From: Randall Hicks <r@rthicksconsult.com>
Sent: Tuesday, May 3, 2016 9:06 PM
To: Bratcher, Mike, EMNRD
Cc: 'Gonzalez, Luis'; mike@rthicksconsult.com; 'Chris Northcutt'; Patterson, Heather, EMNRD; Billings, Bradford, EMNRD
Subject: RE: Clayton Williams Jenna

From: Bratcher, Mike, EMNRD [mailto:mike.bratcher@state.nm.us]
Sent: Tuesday, May 3, 2016 4:18 PM
To: Randall Hicks
Cc: 'Gonzalez, Luis'; mike@rthicksconsult.com; 'Chris Northcutt'; Patterson, Heather, EMNRD; Billings, Bradford, EMNRD
Subject: RE: Clayton Williams Jenna

To: Bratcher, Mike, EMNRD
Cc: 'Gonzalez, Luis'; mike@rthicksconsult.com; 'Chris Northcutt'
Subject: Clayton Williams Jenna

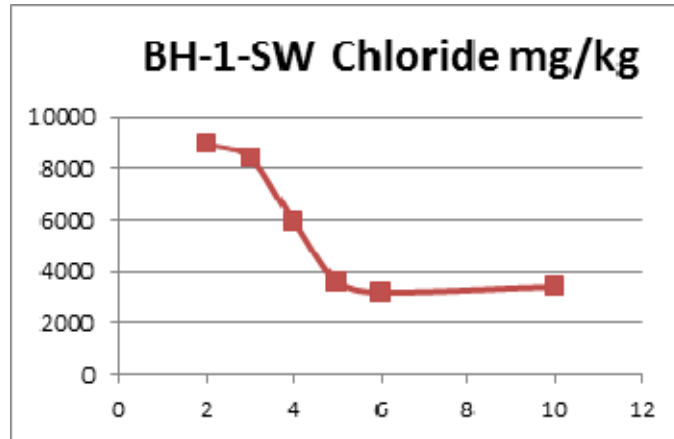
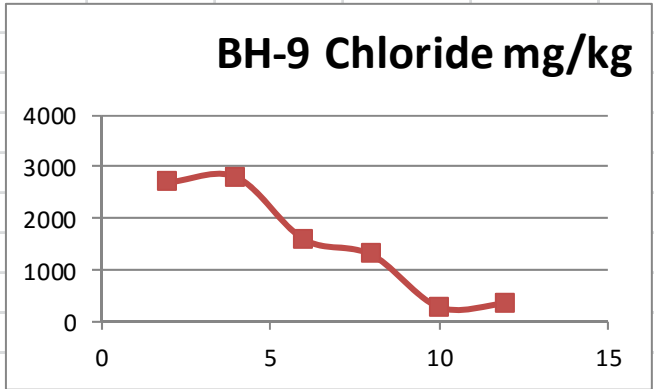
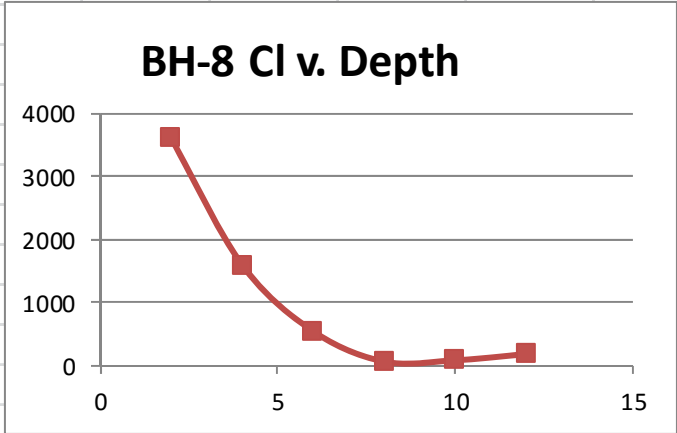
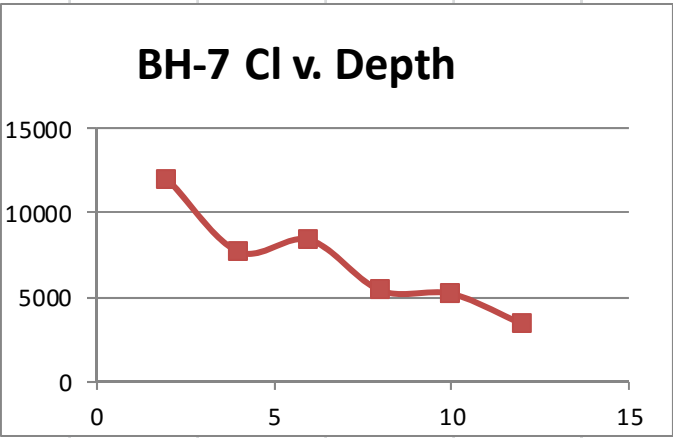
Thank you for the information. I notice that figure 6 is titled "Proposed Chloride Flushing Remedy". At this time, OCD does not have a recent remediation proposal for this site, and I believe the last one was denied. Please be advised, as we discussed, all work being done at the Jenna Com site is not per an OCD approved remediation proposal. My understanding is that one will be formulated based on a delineation of the entire site. Please let me know if this is incorrect.

You are correct, sir. What was sent to you was a DRAFT. There can be no formal remediation proposal submitted until the site is characterized.

The purpose of the DRAFT was to start a discussion. The purpose of delineation is to determine if that discussion really has any merit.
